Town of Hilton Head Island Regular Design Review Board Meeting

**February 12, 2019 – 1:15 p.m.
Benjamin M. Racusin Council Chambers**

EXTERIOR MODIFICATIONS TO HARGRAY RETAIL BUILDING 'A'

STREETSCAPE ELEVATION

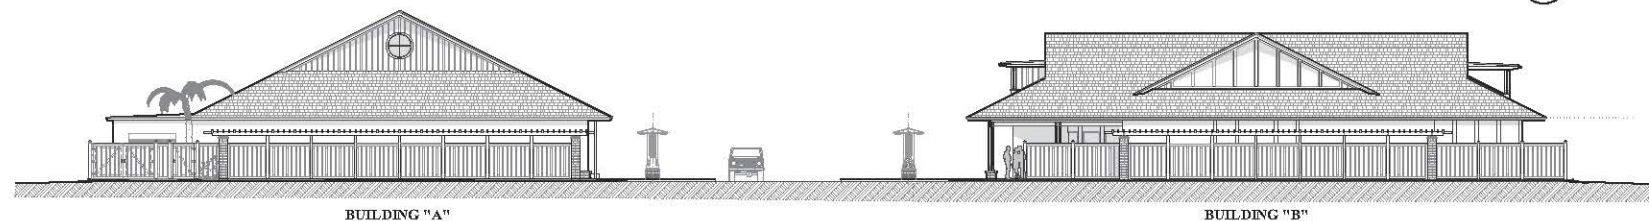
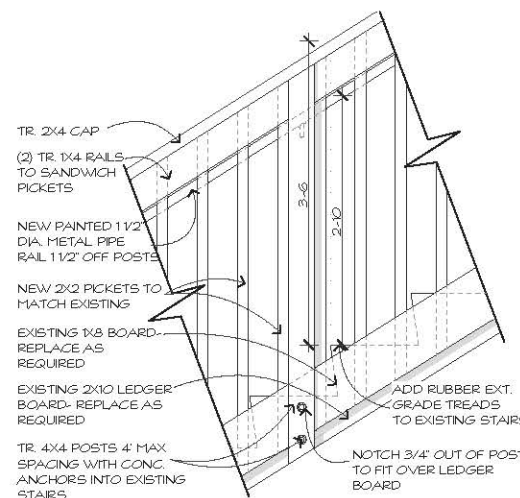
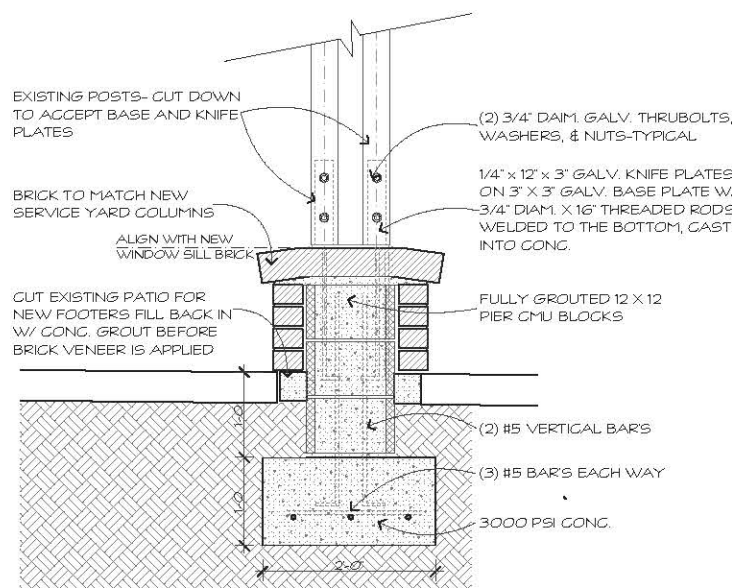
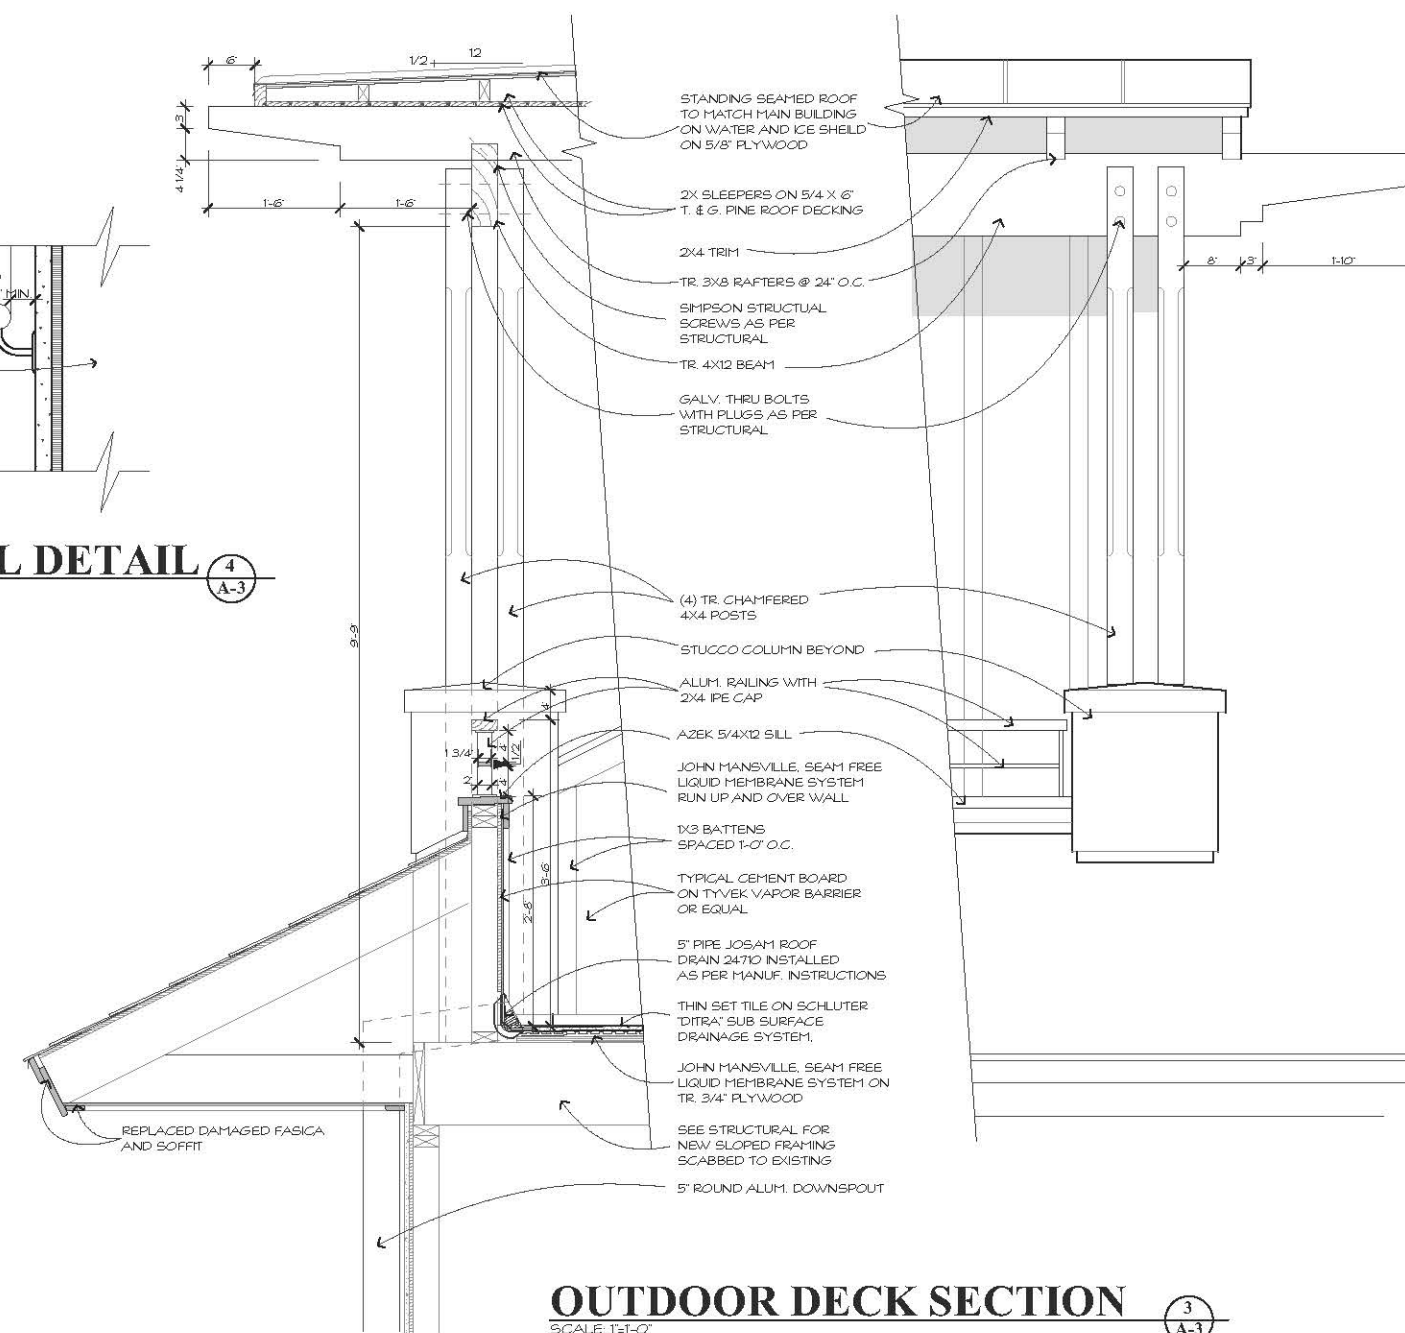
1. Plans shall be revised to specify the color of the aluminum hand rail.
2. Plans shall specify all electrical wiring for lighting, ceiling fans, etc. shall be concealed in architectural elements.

APPLICATION MATERIAL				
DRB REQUIREMENTS	Complies Yes	No	Not Applicable	Comments or Conditions
Detail Illustrating Connection to Existing Structure	<input type="checkbox"/>	<input checked="" type="checkbox"/>	<input type="checkbox"/>	How is trellis roof connected to the asphalt shingle roof?

2 SOUTH ELEVATION
A3.1

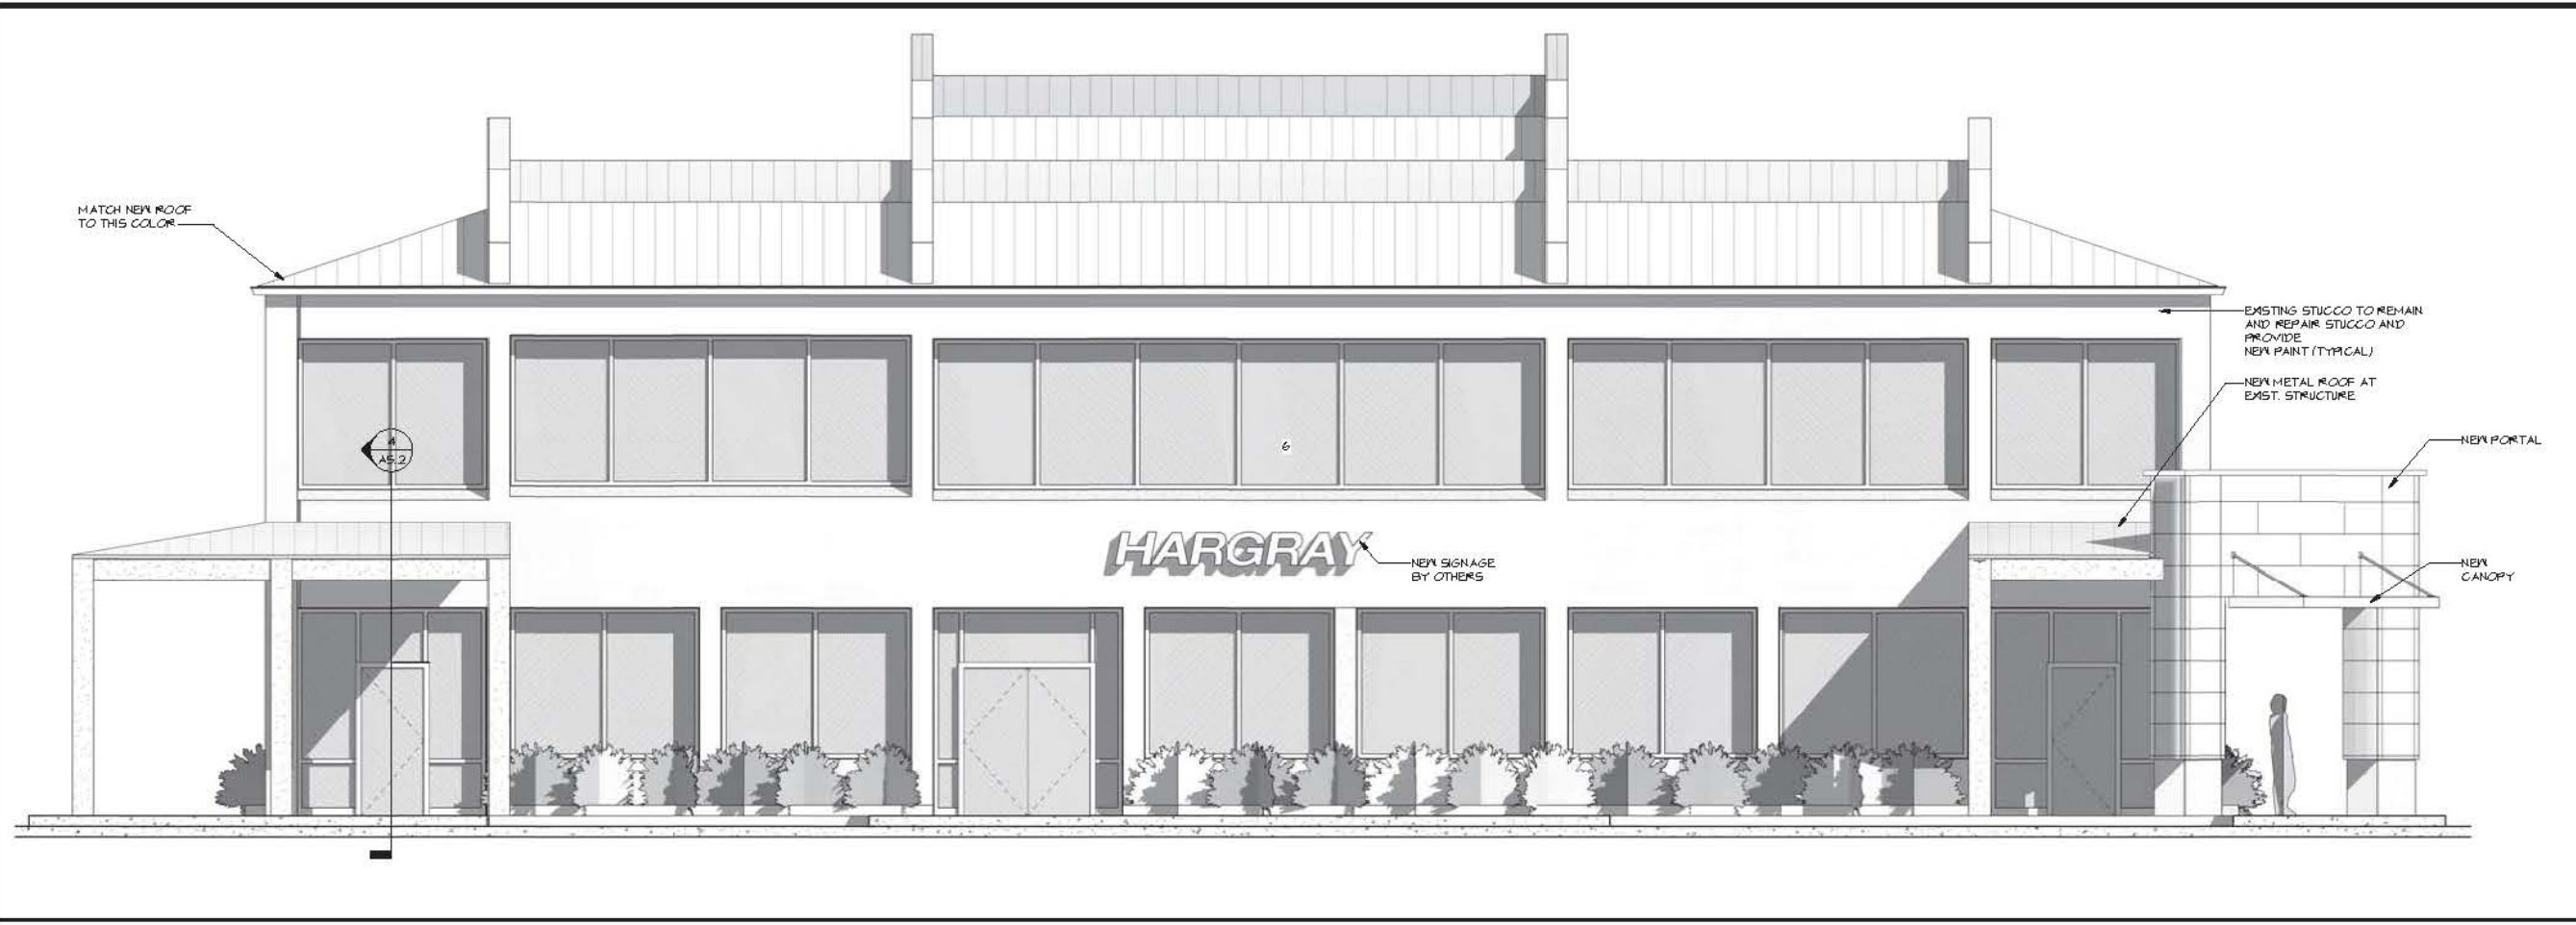
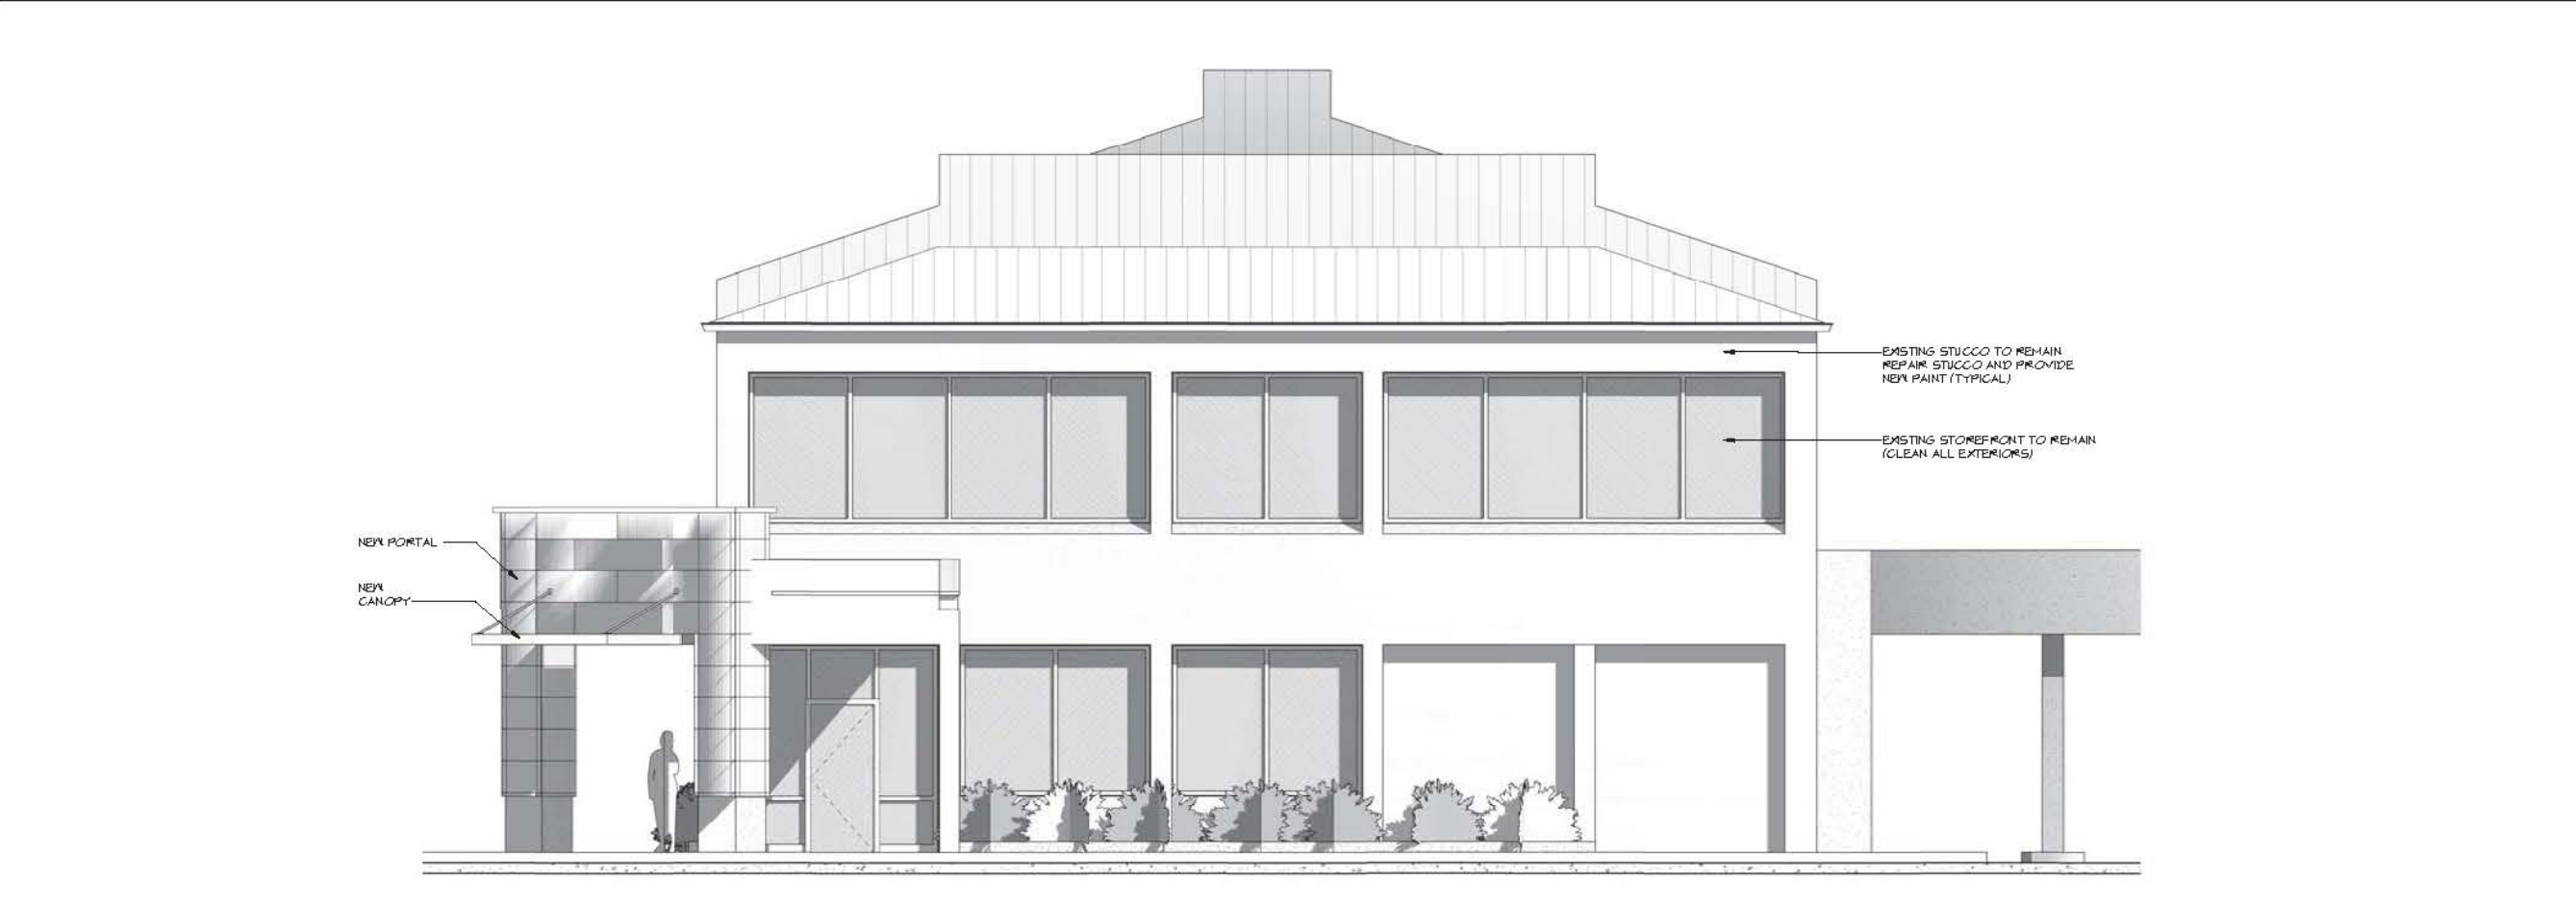
1. Replace the red panels with stucco on the non-visitor entrances.
2. Reduce the height of the face on the side porticos to match what comes off the front entrance.
3. Make those porticos stucco to match the building.
4. The standing seam metal roof shall be green to match the existing lower roof.
5. Replace the visitor entrance sidewalk to a complementary element.
6. Provide an exterior lighting plan.
7. All conditions shall be submitted to Staff for review and approval.

1. The red panels along the existing porticos were replaced with stucco. The Nichiha panels will be located on the new portal only.
2. The height of the fascia along the porticos were reduced.
3. The stucco on the existing porticos will match the building.
4. A note has been added for new standing seam metal roofing to match the (green) existing faux copper roof.
5. The existing sidewalk will be replaced at the visitor entrance sidewalk to a complementary element. We have increased the sidewalk replacement to cover all areas where the existing sidewalk is disturbed to avoid a patchy look.
6. We have provided an exterior lighting plan. All exterior lighting will be 3,000K. I have clouded K2 (recessed fixtures) and GRI (in ground up lights) on the electrical sheets. The sign lights (SP-1) has been removed from the scope of work. Final signage and sign lighting will be submitted by others.
